**PLANS AND SPECIFICATIONS
FOR**

PRIVATE OVERHEAD BRIDGE No. 91604

SIBLEY STREET

SUBJECT: Post Office Skyway Br. No. 91604
over Sibley St. - 2nd to Kellogg
Proj. B-1083

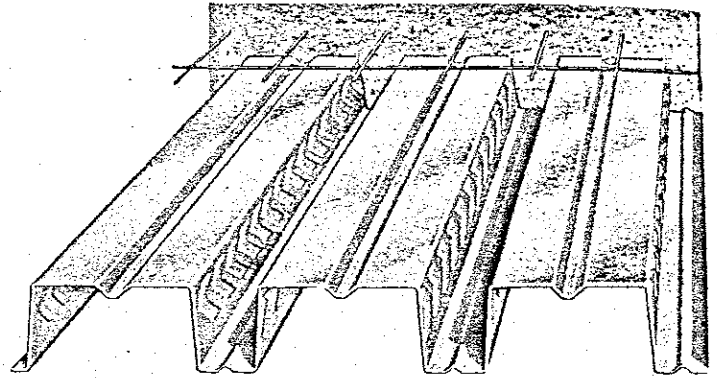
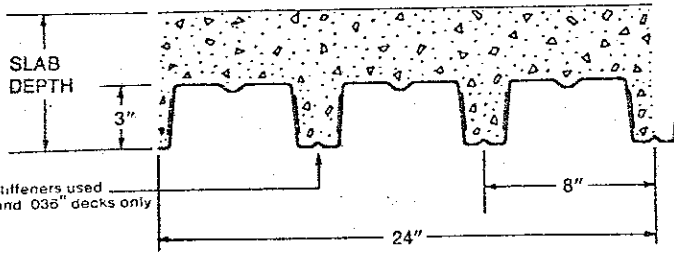
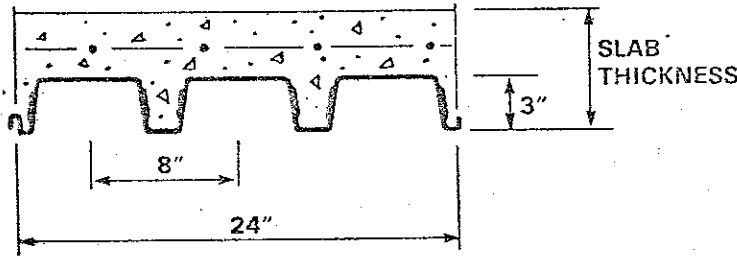
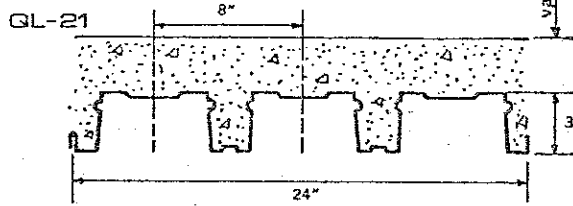
5. Show design loads, allowable unit stresses and design specifications used on Sheet 104.
6. The concrete slab in metal decking is shown in the sections on Sheet 13, but is not detailed as to the reinforcing (if any), size or spacing of corrugations or gauge of materials, and a reference is made to "see structural". This information is not shown on the structural Sheet 104 either.

6. The concrete slab and metal decking is shown in the sections on Sheet 13, but are not detailed as to reinforcing (if any), size or spacing of corrugations or gage of materials, and a reference is made to "see Structural". This information is not shown on Structural Sheet 104 either.

Item #6 In reply to item #6 the spacing of metal floor deck corrugations and gage of material are covered in the specifications by naming three manufacturer's deck types approved for this bridge. The decking is of composite steel to take the tensile forces while the concrete takes the compressive forces. With simple spans from beam to beam no negative moments are created and reinforcing bars are not required over the supports. We have added a welded wire fabric reinforcing in the slab for control of cracking as recommended by the deck manufacturers and now shown on the framing plan on drawing sheet #104. We are enclosing copies of live load tables of each of the three manufacturers. You will note the allowable live load is substantially greater than the required 100 PSF, since the deck used is controlled more by its use as a form to support the wet concrete than by the live load supporting capabilities after the concrete has hardened.
